1720 N. Vine Street
LADOT Case #CEN18-47441

Date: April 10, 2020

Subject: **TRANSPORTATION IMPACT ANALYSIS FOR THE PROPOSED HOLLYWOOD CENTER MIXED-USE PROJECT AT 1720 NORTH VINE STREET**

DRAWING NO.:
A-126

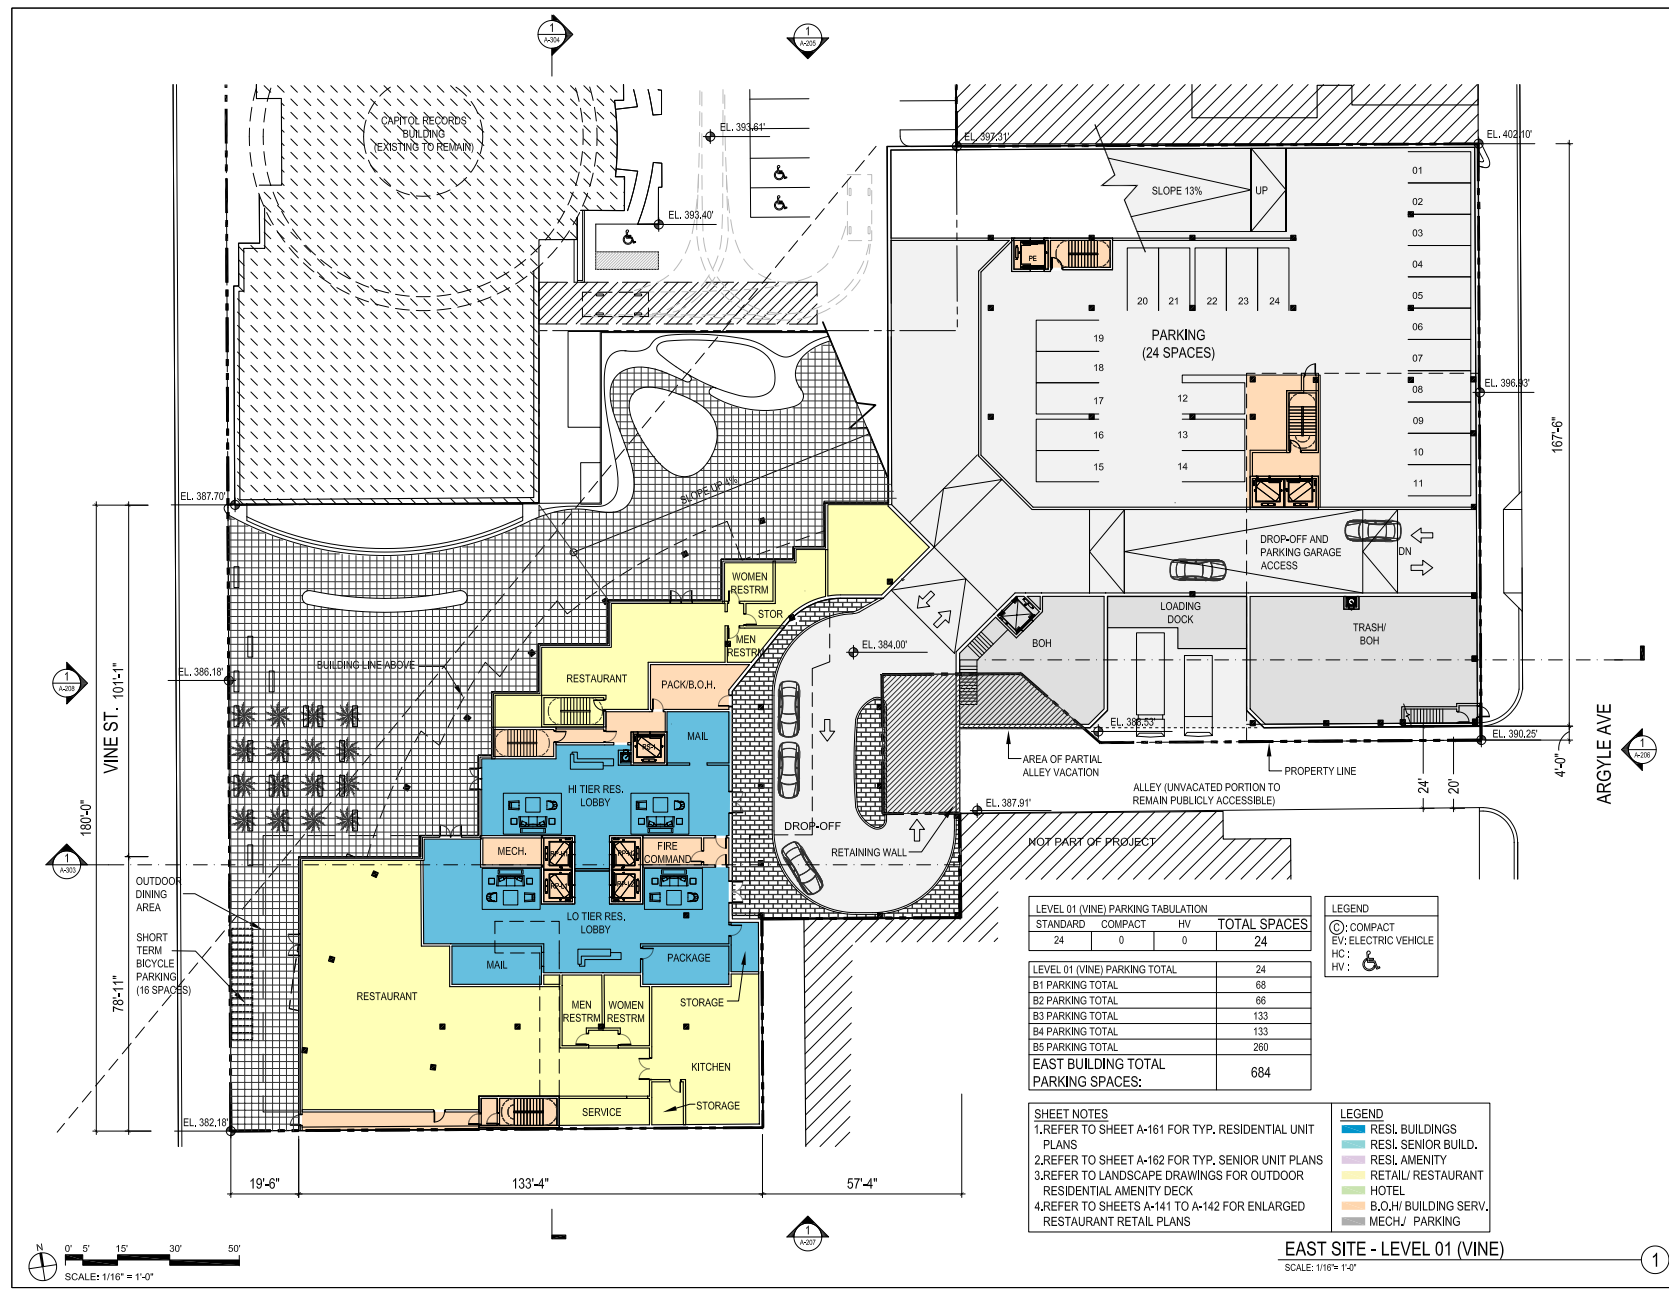
The proposed site plans illustrated in **Attachment 11 and 12** are acceptable to DOT; however, review of the study does not constitute approval of internal circulation schemes and driveway dimensions. Those require separate review and approval and should be coordinated with DOT's Citywide Planning Coordination Section 201 N. Figueroa Street, 5th Floor, Room 550, at (213) 482-7024. Driveway placement and design shall be approved by the Department of City Planning in consultation with DOT, prior to issuance of a Letter of Determination by the Department of City Planning. Any changes to the project's site access, circulation scheme, or loading/unloading area after issuance of this report would require separate review and approval and should be coordinated as well. In order to minimize potential building design changes, the applicant should contact DOT for driveway width and internal circulation requirements so that such traffic flow considerations are designed and incorporated early into the building and parking layout plans.
